DOE/ID-10460
VOLUME 2
October 1996

IN-VESSEL COOLABILITY AND RETENTION OF A CORE MELT

Peer Review Version: July 1995
Final: October 1996

APPENDIX S. REVIEWER LETTERS IN THE ORIGINAL	S-1
APPENDIX T. EXPERT COMMENTS AND AUTHORS' RESPONSES — POINT-BY-POINT	T-1
APPENDIX U. EXPERT COMMENTS AND AUTHORS' RESPONSES — BY TOPIC	U-1
APPENDIX V. CLOSURE	V-1

Figure P.1. A sensitivity on the results of Figure 7.10, carried out by shifting the zirconium-oxidized distribution (Figure 7.3) to the left by 10%.

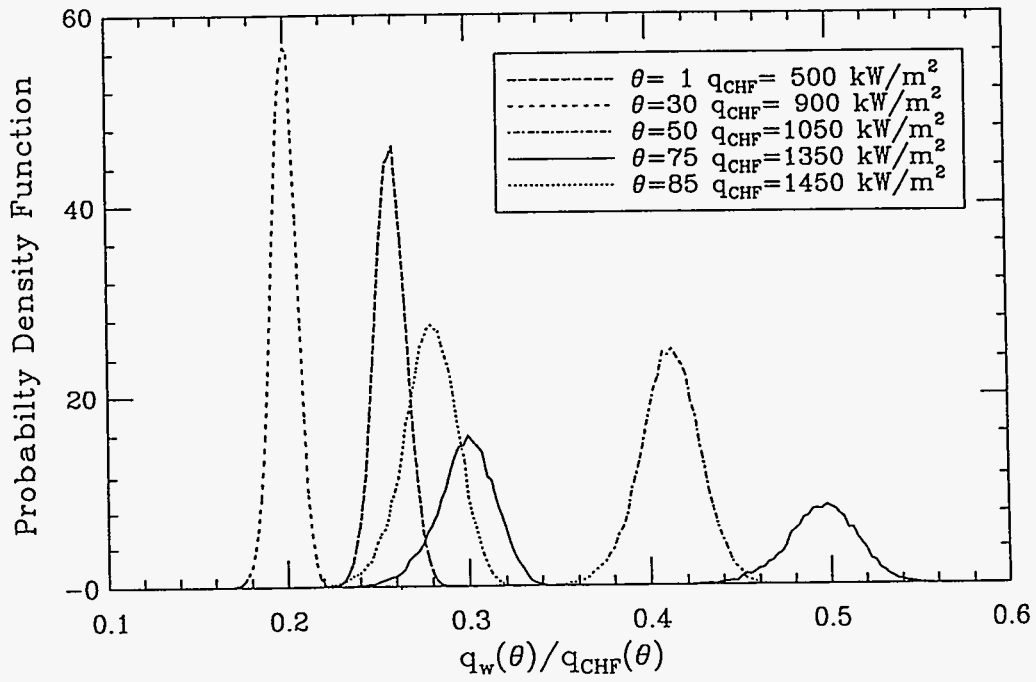
Table P.1. The Additional Parametric Calculations			
Source	Case No.	Description	Results
Kress	1	A reduced emissivity value, $\epsilon = 0.35$	Table P.2
	2	Zr-oxidized distribution, shift by -10%	Figure P.1
Henry	3	Lower-head-to-crust gap conductance	Figure P.2
Olander	4	Transposing power from oxidic to metal pool	Figure P.5
Schmidt	5	Use Kulacki-Emara, Eq. (5.11), for q_{up}	Table P.2
Authors	6	Combine $\epsilon = 0.35$ with Kulacki-Emara	Table P.2
	7	Combine $\epsilon = 0.35$ with $T_{l,m} = 1700$	Table P.2
	8	Combine $\epsilon = 0.35$ with decay heat variations	Figure P.3
	9	Extreme Parametric with reduced pool depths	Figure P.4

- (a) As seen in Figure P.1 (in comparison to Figure 7.10) and in Figures P.2(a),(b), the effects of shifting the oxidized zirconium distribution, and of introducing imperfect crust-vessel contact are negligible.

Figure P.5. The effect of shifting the volumetric heat source (expressed as fraction of total) from the oxidic pool to the metal layer directly.

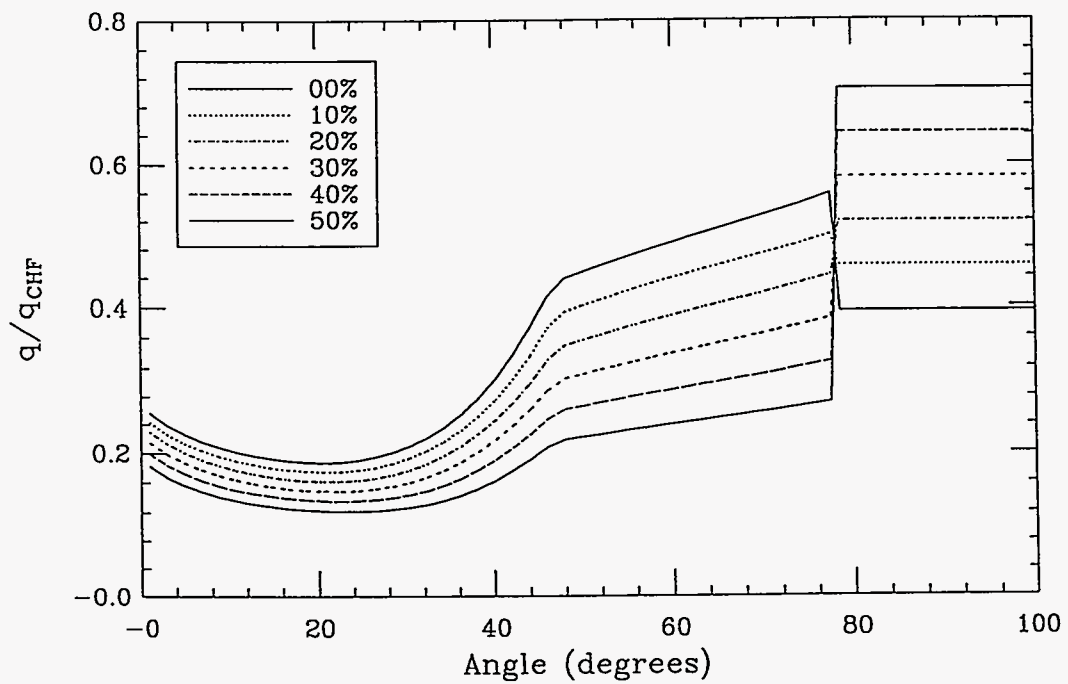
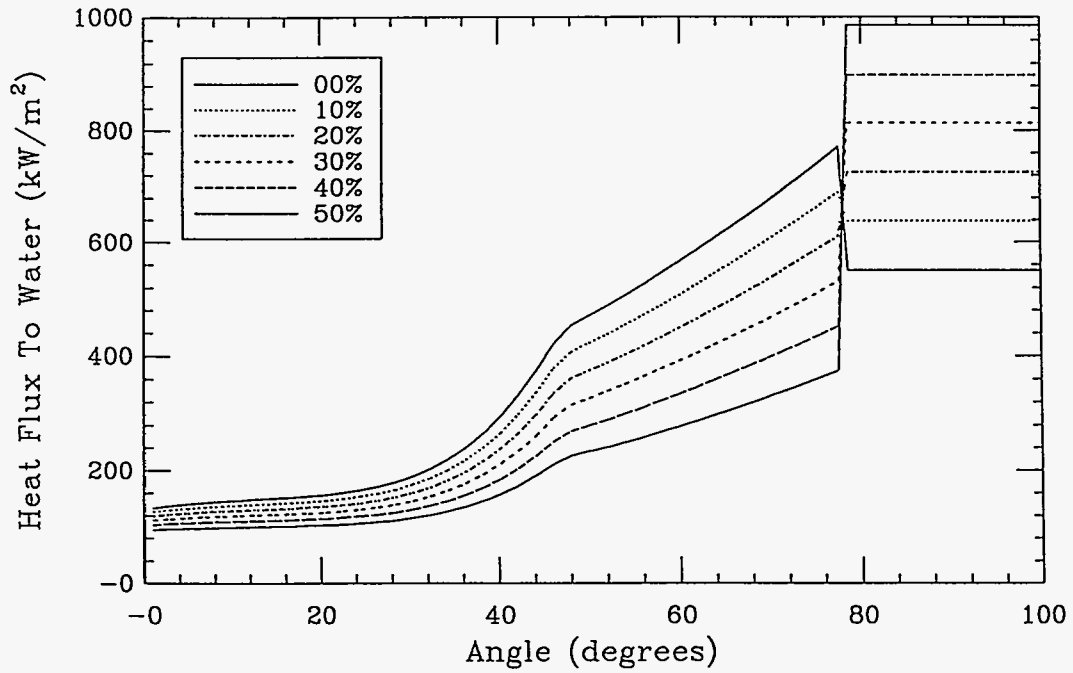
This appendix was prepared in response to specific requests for additional parametric calculations made by reviewers, as indicated in Table P.1. These inspired certain additional cases, as summarized under "authors," also in Table P.1. Many of these cases involve an emissivity value of 0.35, because once it was introduced (Kress) in conjunction with the Extreme Parametric, it became clearly interesting to see what happens as we back off, one parameter at a time, from their extreme conservative specifications. These include the decay power density (the 1.4 MW/m^3 value used in Figure 7.16 in the upper bound of the distribution in Figure 7.8), the depth of the oxidic pool (the 1.18 m is the maximum possible within the available geometry), and the wall melting point (the 1600 K, the lowest possible value, at a eutectic composition, for any iron-zirconium composition where iron is the dominant component). Moreover, it is emphasized that an emissivity value of 0.35 is *outside the physically reasonable range* of this parameter. The minimum possible value is 0.45, obtained for a perfectly clean surface (of a *melt*), and it is expected to increase with impurities (i.e., oxides), or incomplete melting, towards a value of 1.

- (e) In Figure P.5(a),(b), we see that shifting the volumetric heat source from the oxidic pool into the metal layer produces, as expected, a corresponding shift in thermal loads. However, even a 50% shift is not adequate to compromise integrity in the Base Case.

Figure 1. Comparison of Cheung and Haddad Data, Vishnev correlation and ULPU Data

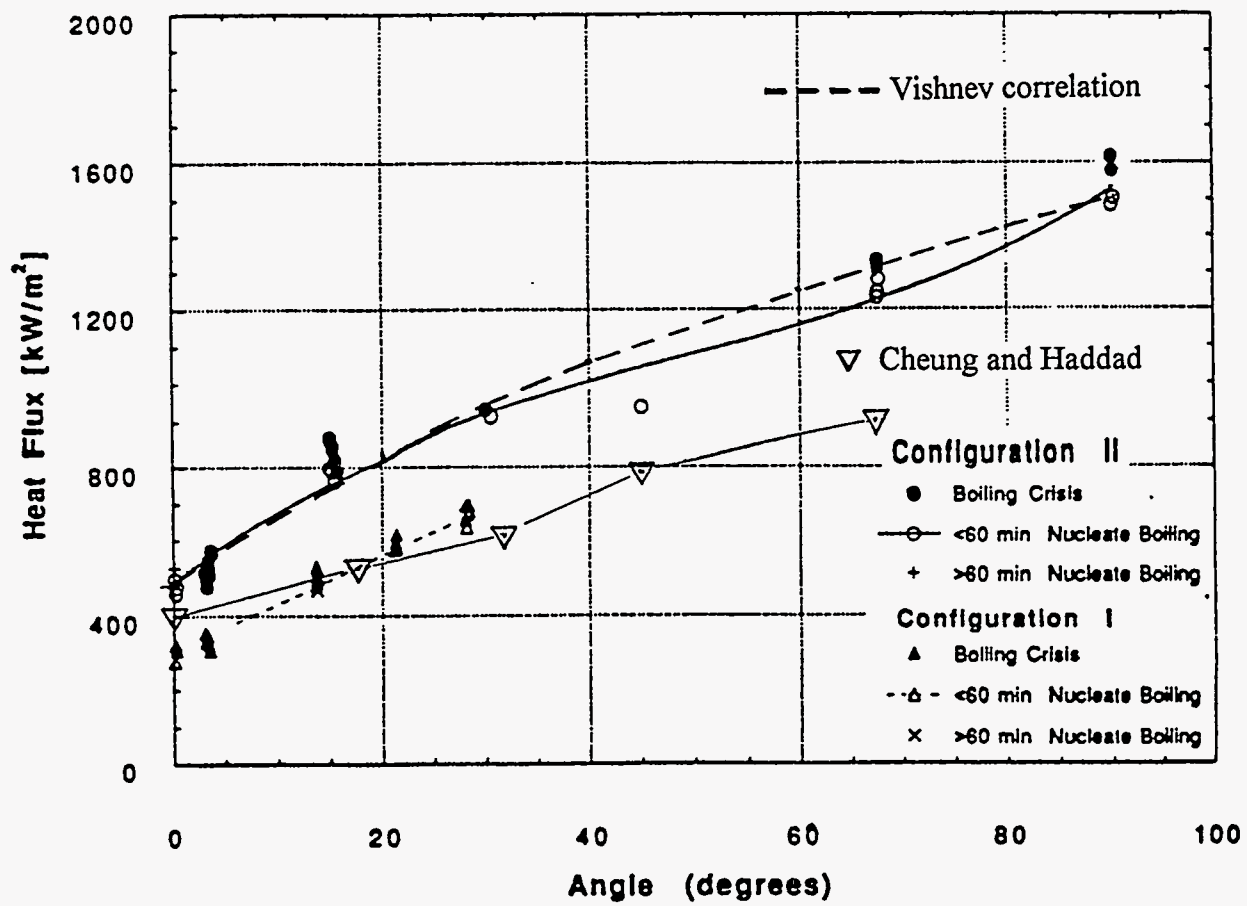
4. It is interesting that the Vishnev correlation (Vishnev et al., “Study of Heat Transfer in Boiling Helium on Surfaces with Various Orientations,” Heat Transfer-Soviet Research, vol. 8, no. 4, p. 104-108) derived from laboratory scale experiments and using helium as a working fluid, actually predicts the ULPU data trend to within 10% (Figure 1). The Vishnev correlation specialized to the nomenclature of the present report is:

12. 4. *It is interesting that the Vishnev correlation (Vishnev et al., “Study of heat Transfer in Boiling helium on Surfaces with Various orientations,” Heat Transfer-Soviet Research, vol. 8, no. 4, p. 104–108) derived from laboratory scale experiments and using helium as a working fluid, actually predicts the ULPU data trend to within 10% (Figure 1). The Vishnev correlation specialized to the nomenclature of the present report is:*

Figure T.1. The present results (• · - • · - •) plotted in the manner suggested by Cheung (1980).

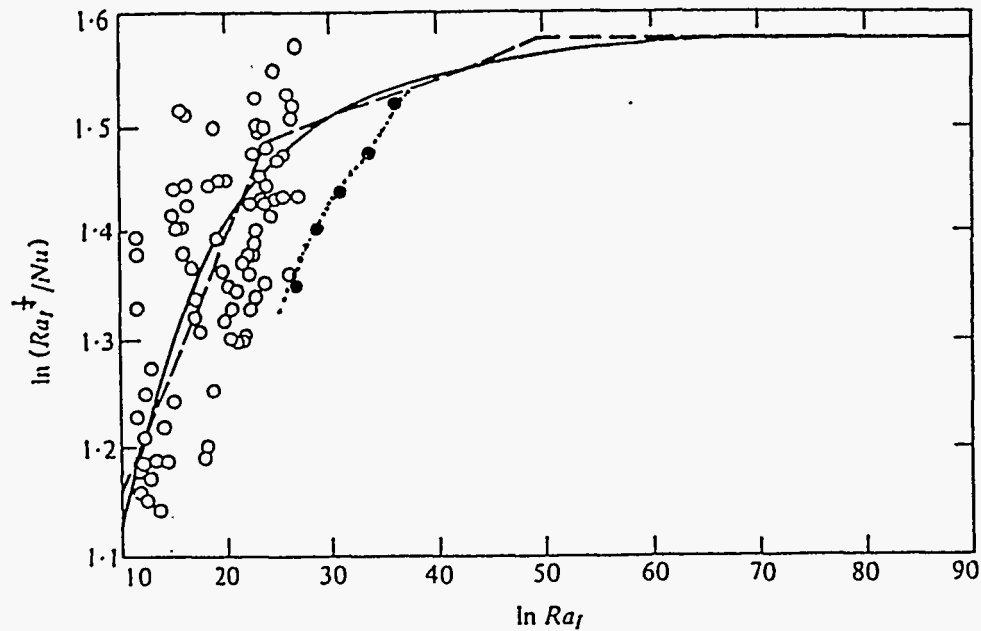
The local flow structure on the external surface of the pie-segment geometry described in Appendix E.1 can not be fully simulated by using the constant-width test Section of the ULPU facility. Although the local heat flux may be matched by using the power-shaping approach, the detailed hydrodynamic behavior of the two phase boundary layer flow can not be fully simulated. For the Pie-segment geometry, the cross-sectional flow area is not constant but increases downstream in the flow direction. The local power levels in the lower Part (i.e., upstream

Not true. The whole purpose of the power shaping principle in ULPU is to represent what the reviewer calls here the “divergent [sic] effect.” This paragraph, and in particular the second sentence (“Although the local heat flux may be matched by using the power-shaping approach, the detailed hydrodynamic behavior of the two-phase boundary layer can not be fully simulated”) lead us to believe that the reviewer did not fully understand the power-shaping principle and its implications. As shown in Figure E.3 of Appendix E.1, there is a sufficiently close approach of the upstream boundary layer for matching angles (θ_m) as small as 10° , and the simulation keeps getting better for larger angles. Only the region $\theta_m < 10^\circ$ is, strictly speaking, deficiently (but conservatively) simulated in this respect, by using a uniform heat flux, but extensive sensitivity-type experiments indicate that the effect of this deficiency is negligible.
